JUNEAU INTERNATIONAL AIRPORT JNU RUNWAY 8/26 REHABILITATION CBJ CONTRACT No. E14-259 AIP No. 3-02-0133-60-2014

RECORD DRAWING
 THESE DRAWINGS HAVE BEEN PREPARED BY STANTEC FROM INFORMATION AND DOCUMENTS SUPPLIED BY THE GENERAL CONTRACTOR AND INFORMATION GATHERED BY STANTEC. STANTEC BELIEVES THESE DRAWINGS ARE AN ACCURATE REPRESENTATION OF THE CONSTRUCTION TO THE BEST OF OUR KNOWLEDGE. AN AS-BUILT SURVEY HAS NOT BEEN PERFORMED. STANTEC ASSUMES NO RESPONSIBILITY FOR ERRORS OR OMISSIONS INCORPORATED AS A RESULT OF INACCURATE INFORMATION PROVIDED TO STANTEC. FIELD VERIFY INFORMATION CONTAINED HEREON BEFORE USING.
 By: *[Signature]* Date: 5/27/16

JGL	6/25/14	CONFORMED DOCUMENTS
JGL	5/27/16	ASBUILTS
BY	DATE	REVISIONS

3 DITCH - TAXIWAY A (CUT CONDITION)
 C14 SCALE: NOT TO SCALE

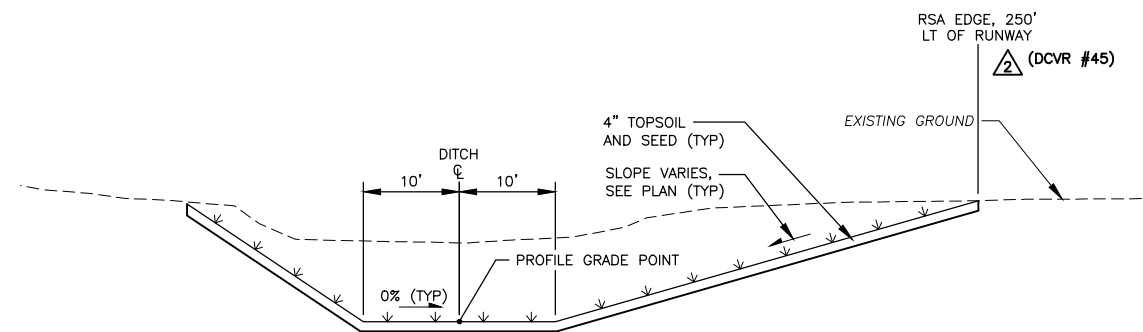
2 (DCVR #45)

- 1. WARP CUT SLOPE AROUND WIND CONE. TOP OF SLOPE SHALL BE NO CLOSER THAN 12' FROM THE WIND CONE POST.

4 TYPICAL PAVEMENT TRANSITION AT TAXIWAY INTERSECTIONS
 C37 SCALE: NOT TO SCALE

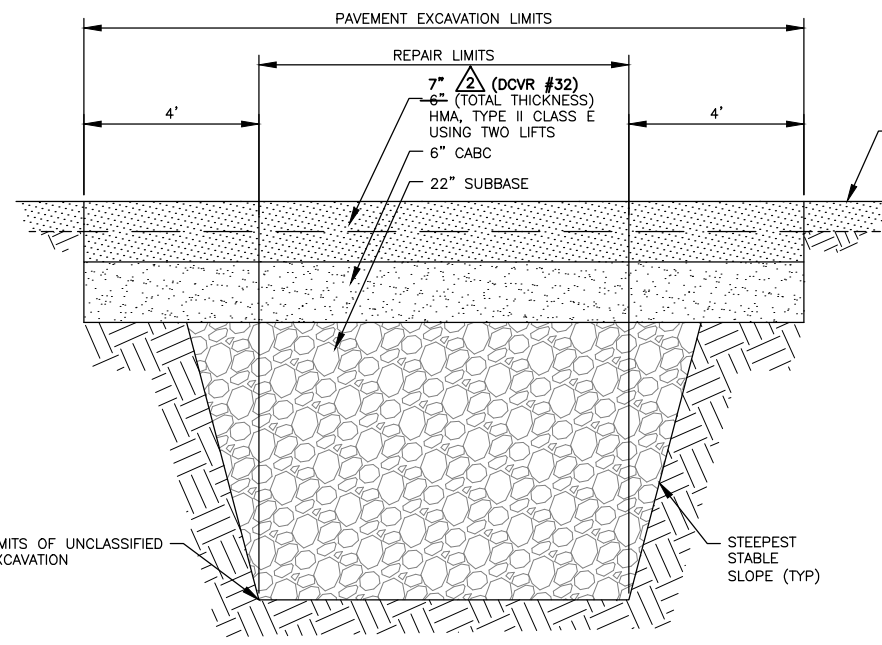
NOTES
 1. MODIFY COLD PLANE DEPTH FROM ~~ZERO INCHES~~ ^{ONE INCH} AT 75 FEET LEFT TO 3" AT 100 FEET LEFT TO TRANSITION TOP LIFT OF OVERLAY TO MATCH EXISTING TAXIWAY PAVEMENT. (RFI #57R) Δ
 2. APPLY TACK COAT TO ALL COLD PLANED SURFACES AND SUCCESSIVE LIFTS PRIOR TO PAVING.
 3. TRANSITION THE RUNWAY SHOULDER SLOPES TO THE TAXIWAY SHOULDERS OVER 50 FEET PRIOR TO THE POINT OF CURVATURE OF THE TAXIWAYS SHOULDER PAVEMENT EDGE AT THE NEW RUNWAY SHOULDER PAVEMENT EDGE. (DCVR #36) Δ
